AGENDA

December 18, 2012

Town Hall BOS Meeting Room - 6:30 PM

CONDOMINIUM PLAN
PINE VALLEY MILL
COMMERCIAL CENTER / RESIDENCES AT THE MILL

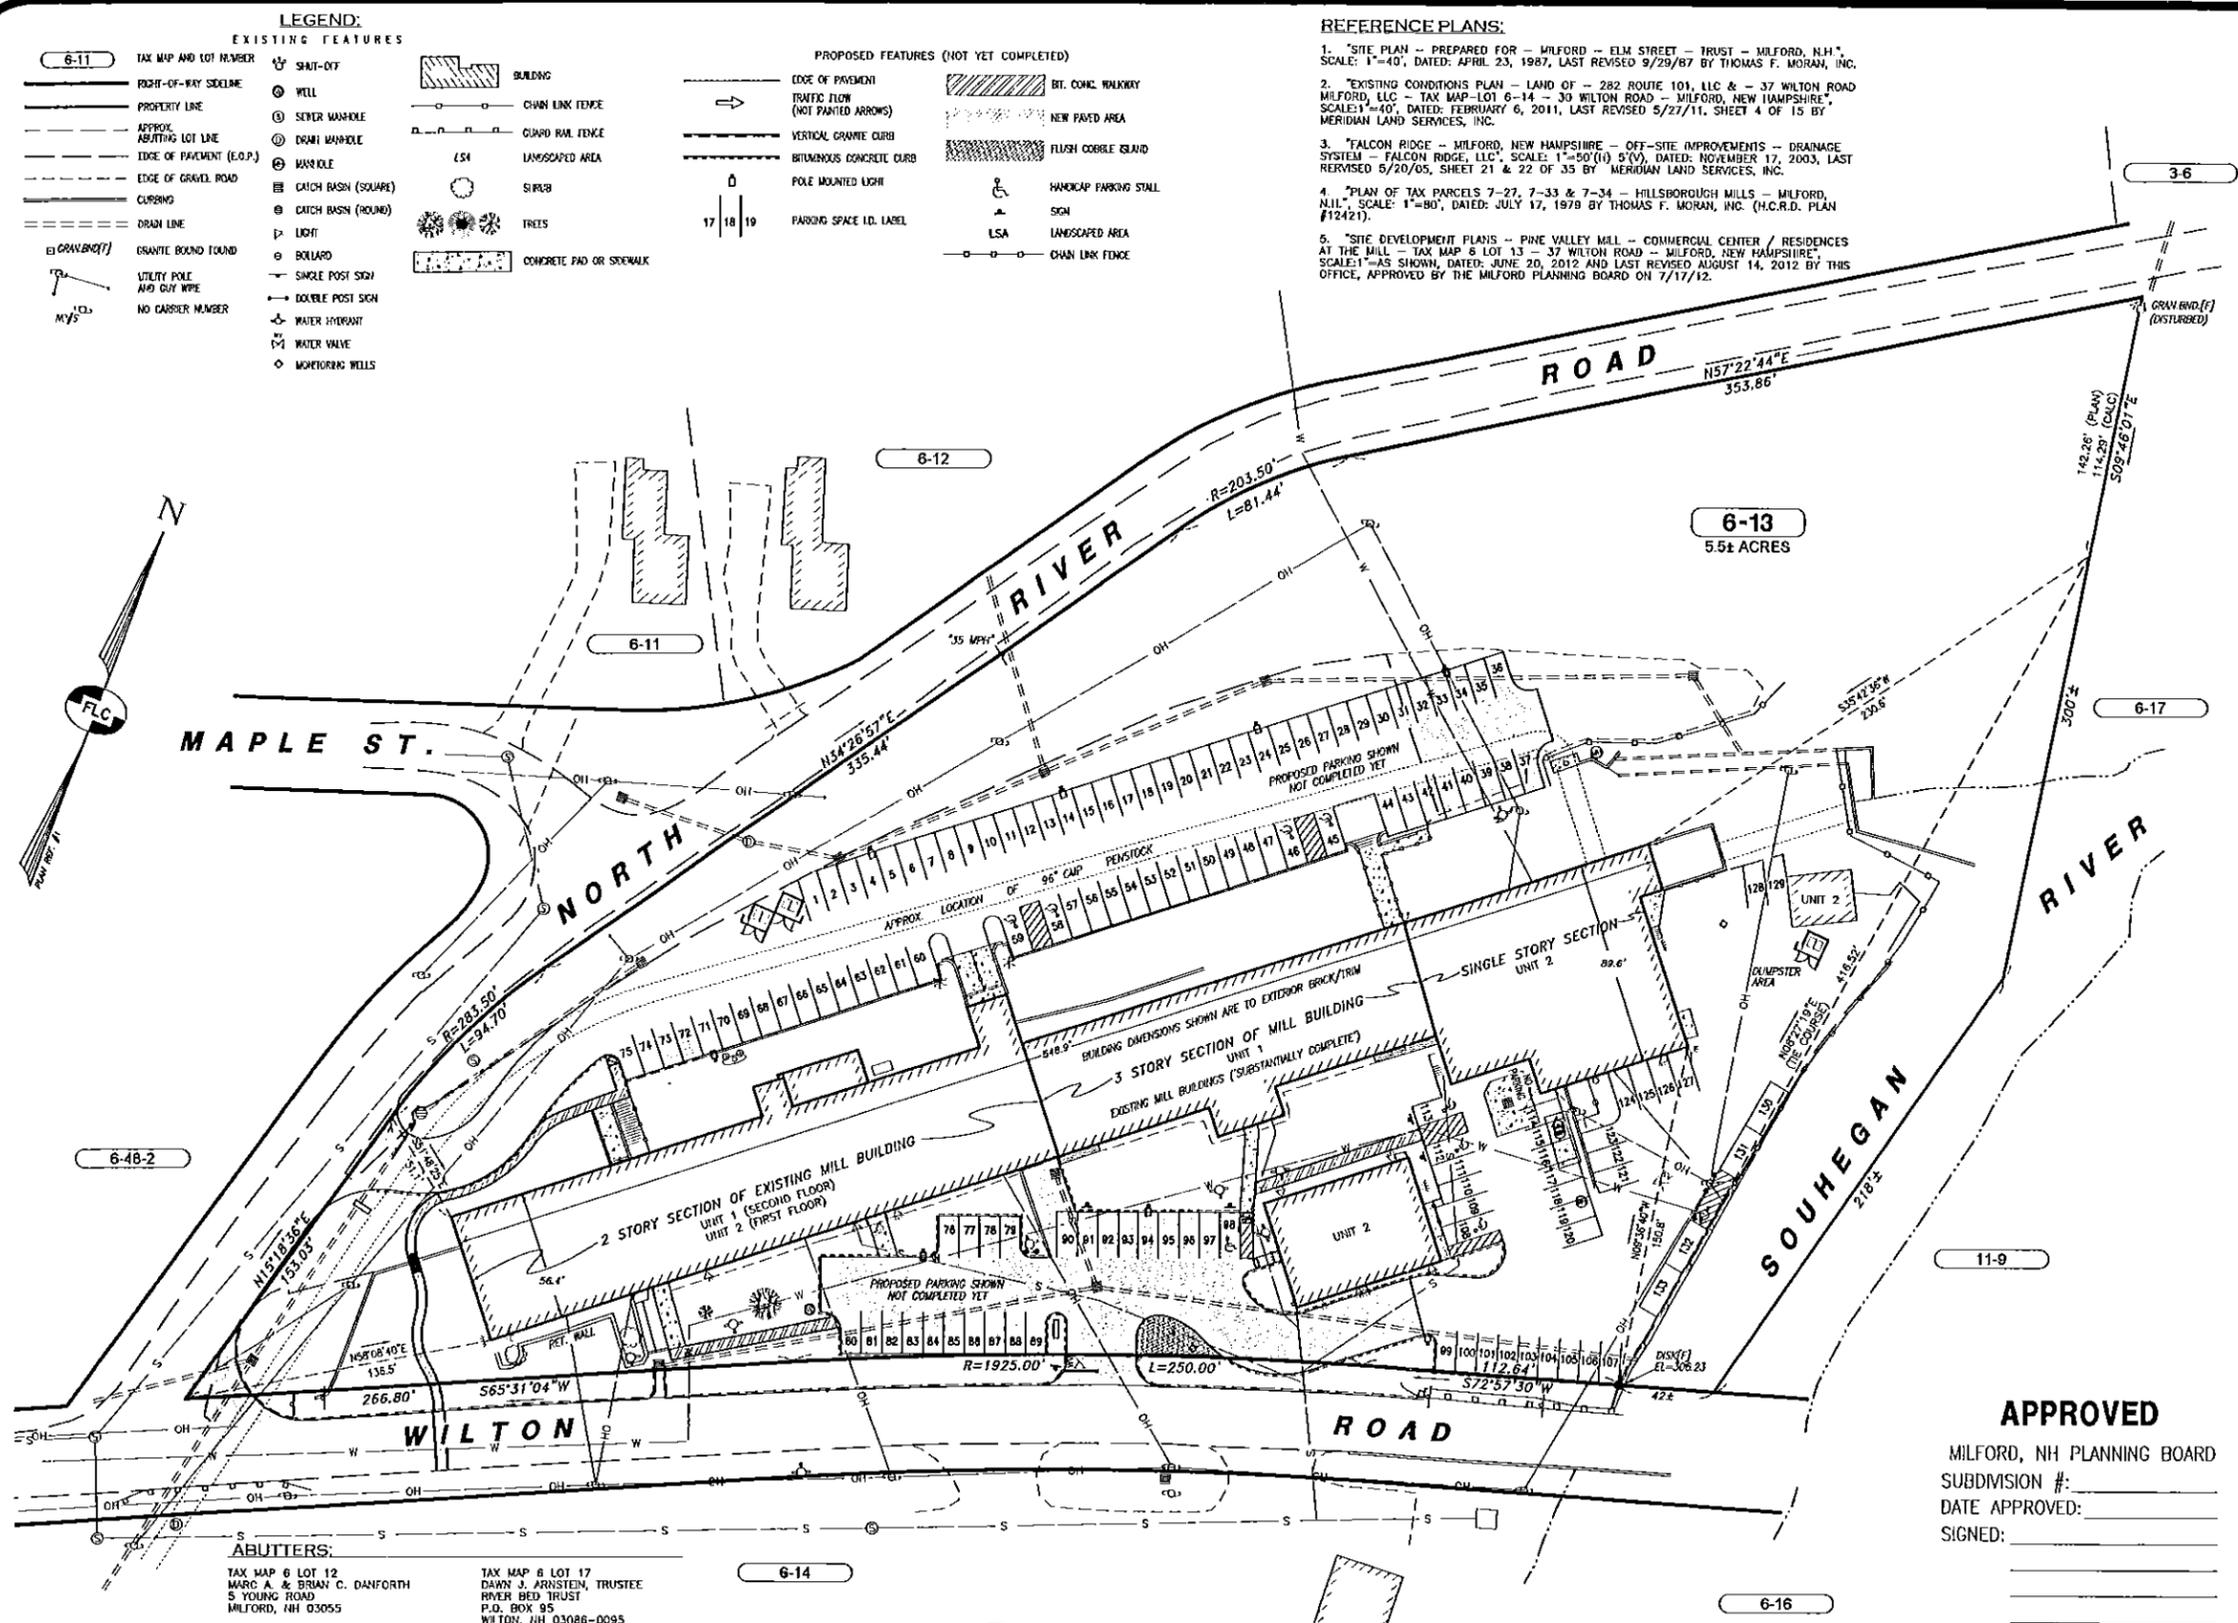
Zoning Administrator – A condominium plan approval is required to legally allow the conversion of the Mill into a residential unit and a commercial unit for ownership transfer. The plan meets condominium plan requirements.

1. That the applicant provides copies of the recorded Condominium documents to the Planning Department.

PRELIMINARY COMMERCIAL SITE PLAN
CIARDELLI FUEL COMPANY, INC.
TAX LOT MAP 7 LOT 5-5
HOLLOW OAK LANE
MILFORD, NEW HAMPSHIRE

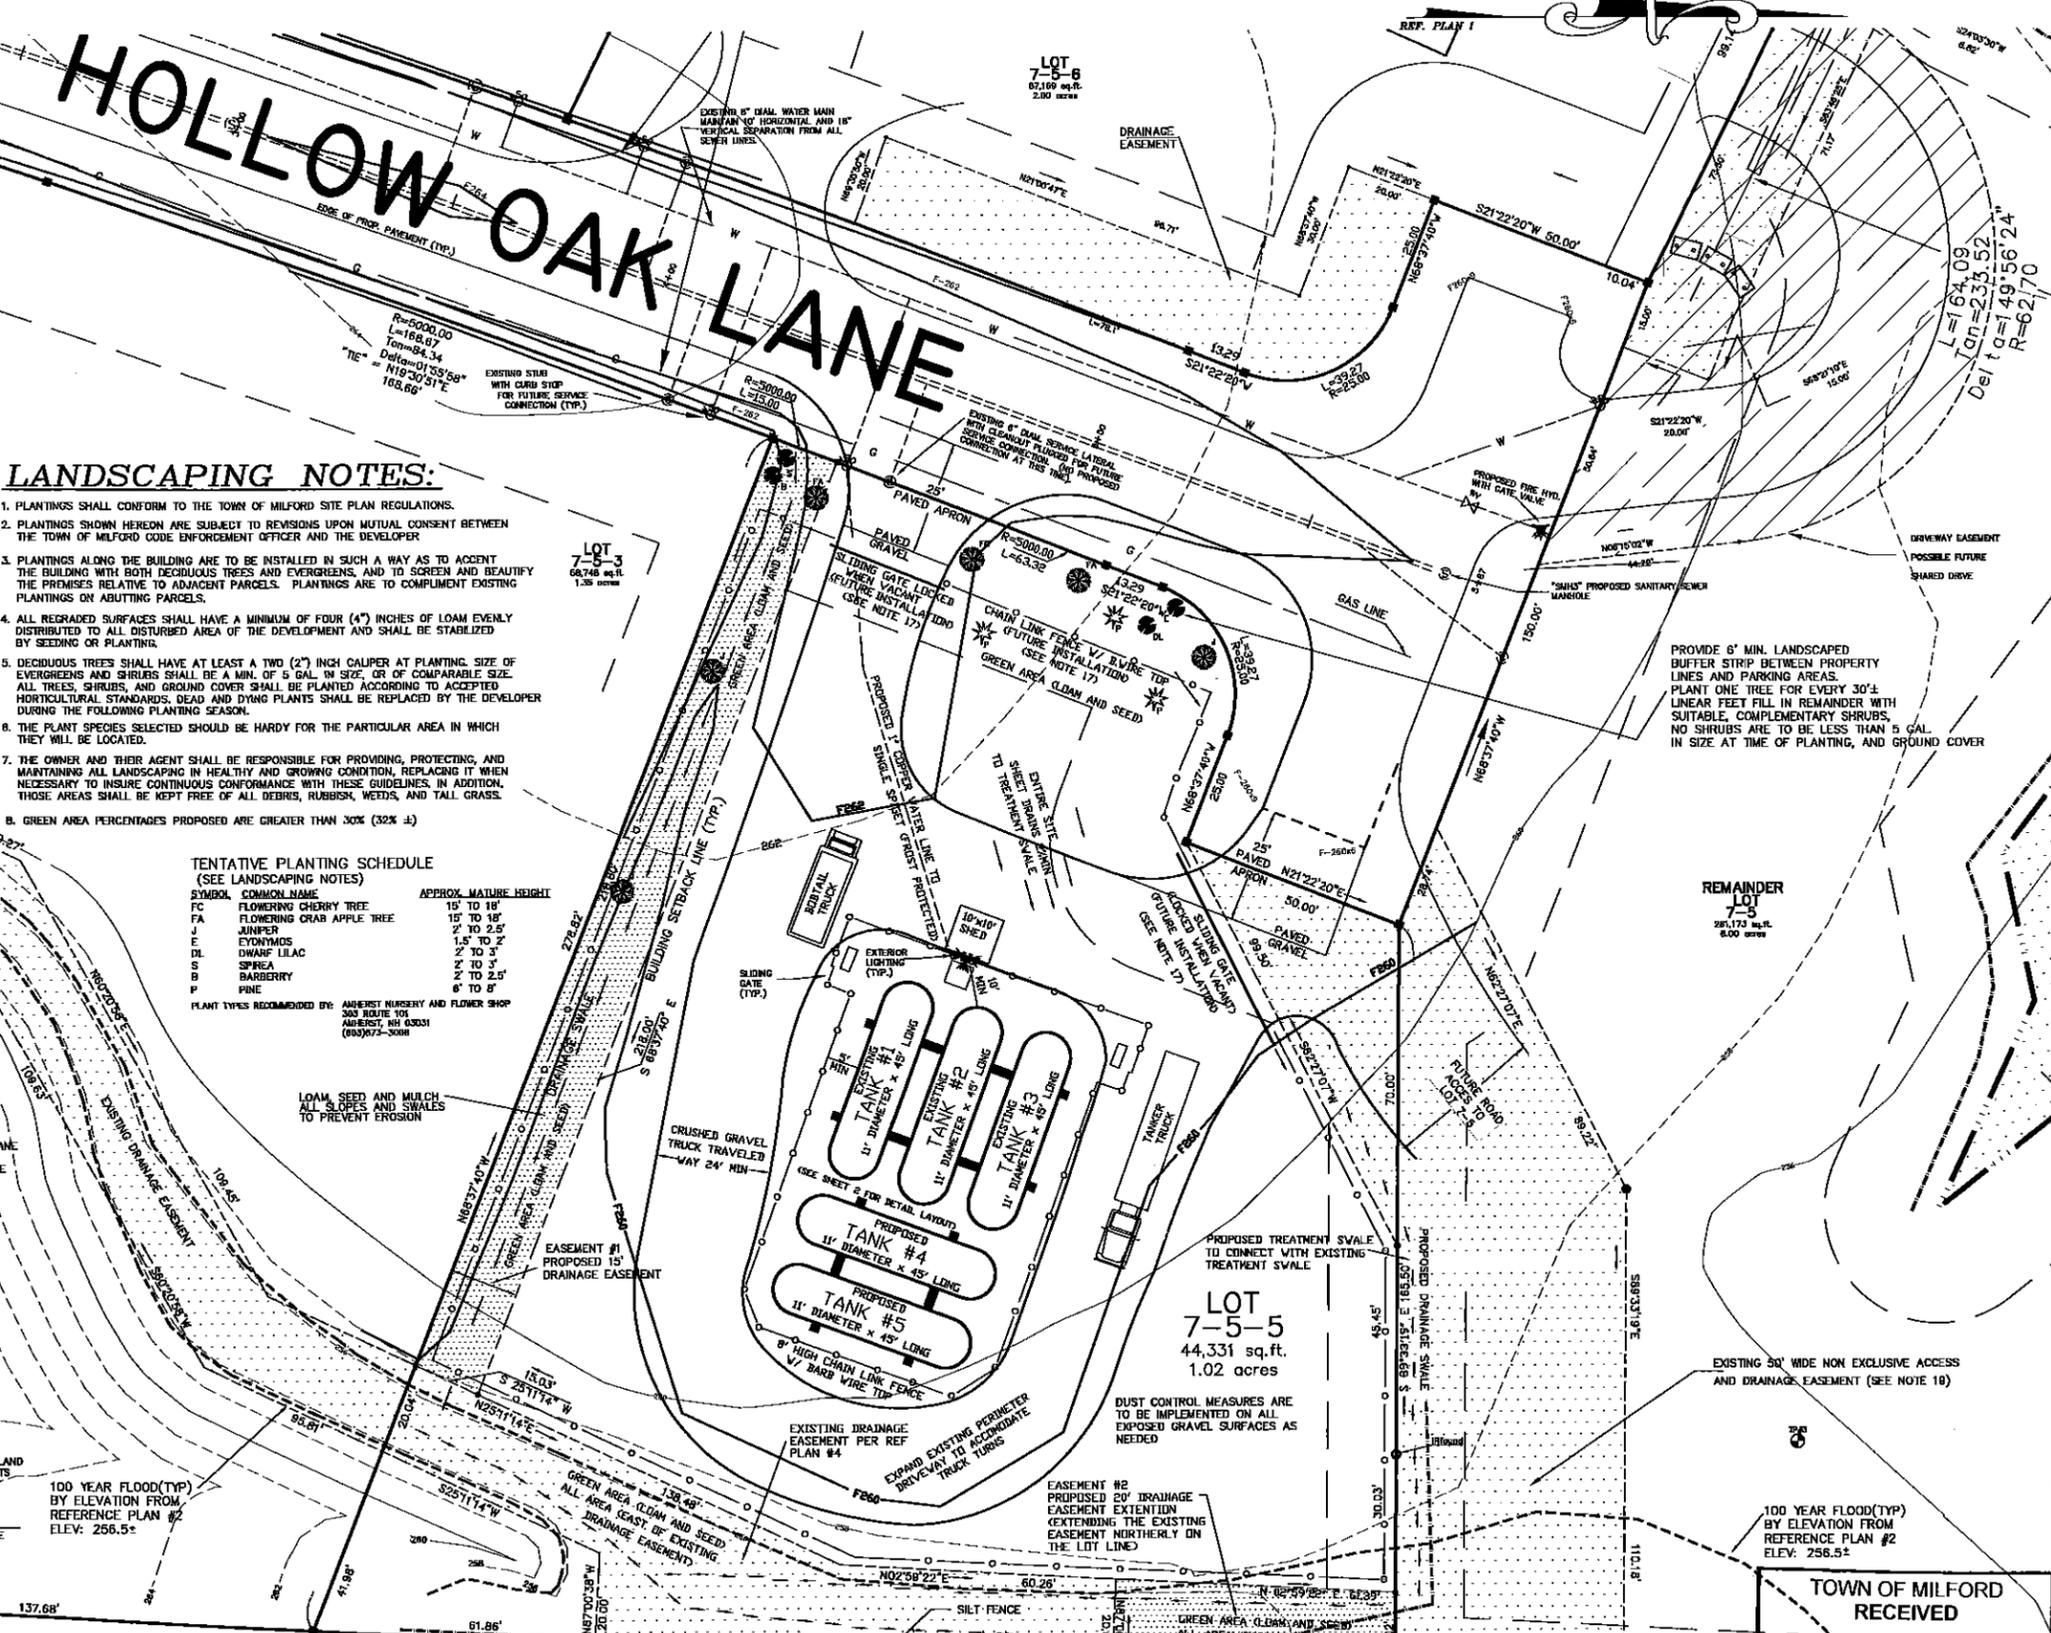
Environmental Coordinator – It does not appear that the proposed amendment significantly alters the site drainage. However, it would be beneficial for the engineers to confirm this – perhaps as a plan note.

- 1. Change all occurrences of the use of “proposed drainage easement”, “proposed drainage swale” and “proposed treatment swale” to existing.
- 2. A note be added to the plan stating the proposed additional propane storage tanks shall not alter the site drainage.
- 3. Update revision dates on plan.
- 4. If an additional sliding gate is proposed in the area of new tanks it shall be updated on the plan.

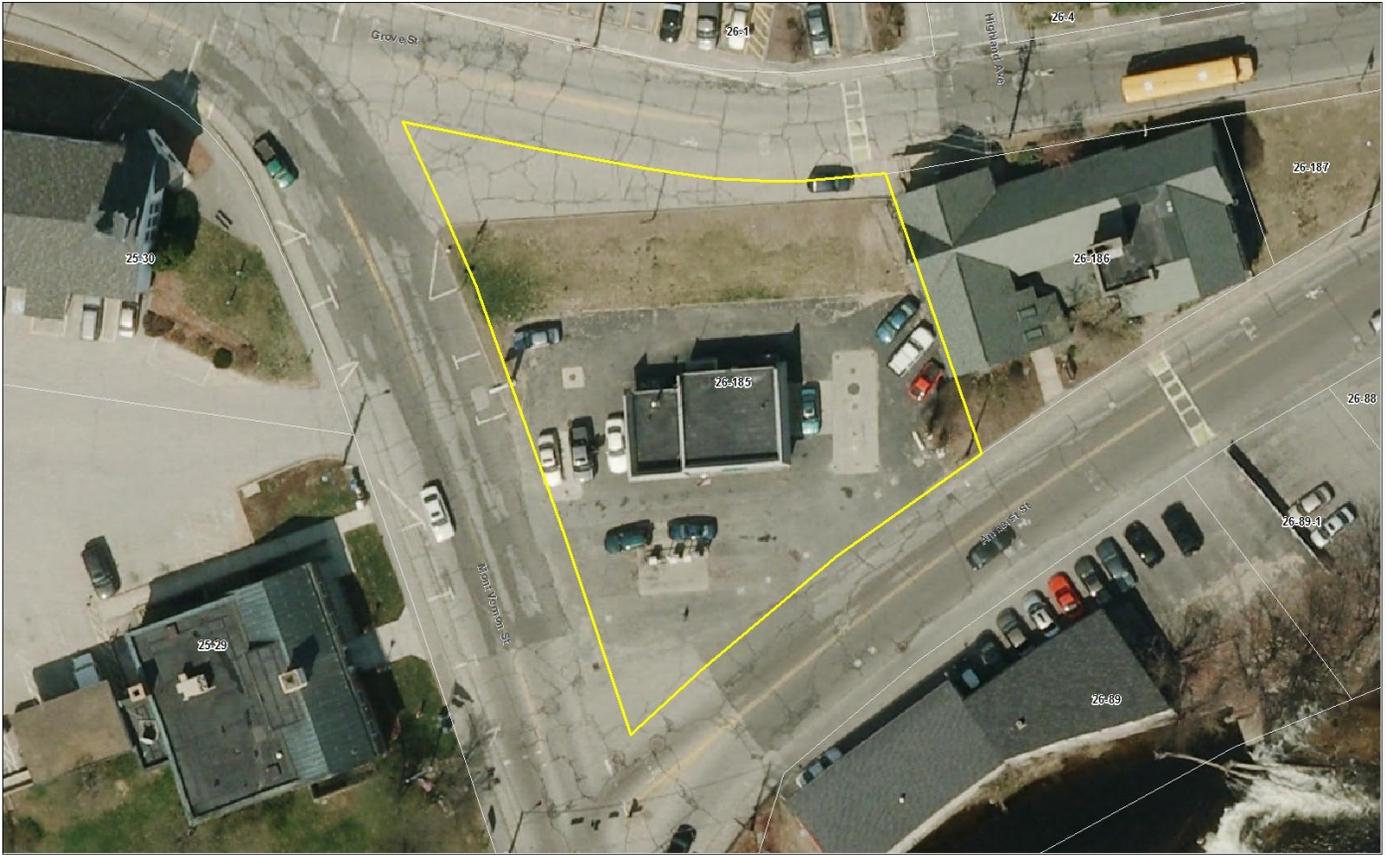
Zoning Administrator – Proposed vehicle sales is allowed by zoning in the C – commercial district. Because the limited display area will be located in an already improved, paved location there is no site impact. Would recommend the waiver be approved to formalize the vehicle sales use that has been historically operating on the site since before zoning. This validation is necessary to meet State licensing requirements.

Code Enforcement/Building – I would just make sure the Planning Board verifies there is enough space for 4 vehicles in the current location, In the past there has only been 1 vehicle for sale at a time at that location and it seems a little small for 4.
